IRPS5401 Errata Final Silicon

PSS DCDC Enterprise Power
January 2021

IRPS5401 Errata Final Si --Summary

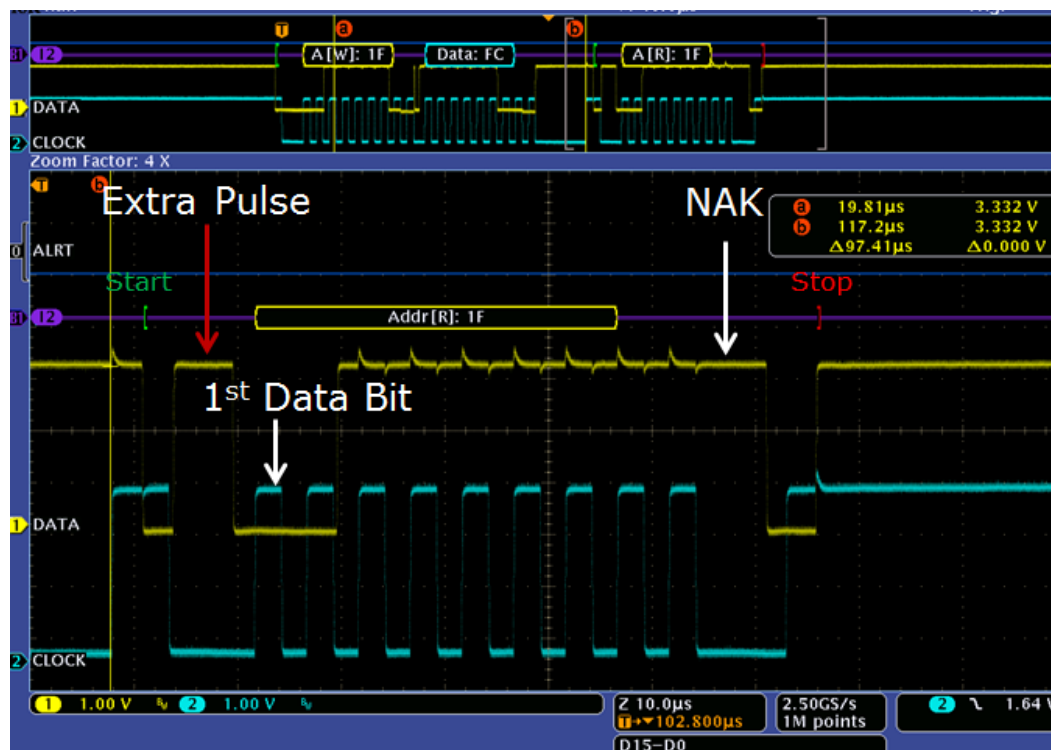
Item	Errata Description					
1	Errata	During Power On Reset (POR), the last 24 bits of data stored in NVM are not restored correctly to the working registers. These 24 bits affect PMBus commands related to the LDO output				
		LDO PMBus command bits not restored correctly	Data Source in NVM	Acceptable Values in Source Registers		
		STATUS_INPUT mask [7:5]	VIN_UV_WARN_LIMIT; bits 6 to 8	Set to 0. Since VIN_UV_WARN_LIMIT bits 6 through 9 must be set to 0, the largest value that can be set without causing an issue is 0xC83F → 0.49V.		
		STATUS_TEMPERATURE mask[7:6]	POWER_GOOD_ON; bit 0			
			VIN_UV_WARN_LIMIT; bit 9			
		STATUS_CML mask [7:1]	POWER_GOOD_ON; bits 1 to 7	Set bits 1, 5, 6, and 7 to 0. Bits 2, 3 and 4 can be set to 1 because the corresponding CML mask bits are not supported. Bits 8 to 11 can be set to 1 if a PG delay is acceptable The table below shows allowable values		
		MFR_TPGDLY[3:0]	POWER_GOOD_ON; bits 8 to 11	VOUT_MODE = -8	(recommended)VOUT_MODE = -9

In Tracking mode, set POWER_GOOD_ON & OFF commands to 0. They are fixed thresholds set by VIN

power_good_on: Non-tracking mode: this command sets the output voltage above which the Power Good indication is asserted. Tracking mode: the Power Good On threshold is fixed at 87.5% of (VIN/2). Resolution is specified by VOUT_MODE in non-tracking

power_good_off: Non-tracking mode: this command sets the output voltage below which the Power Good indication is de-asserted. Tracking mode: the Power Good Off threshold is fixed at 81.25% of (VIN/2). Resolution is specified by VOUT_MODE.
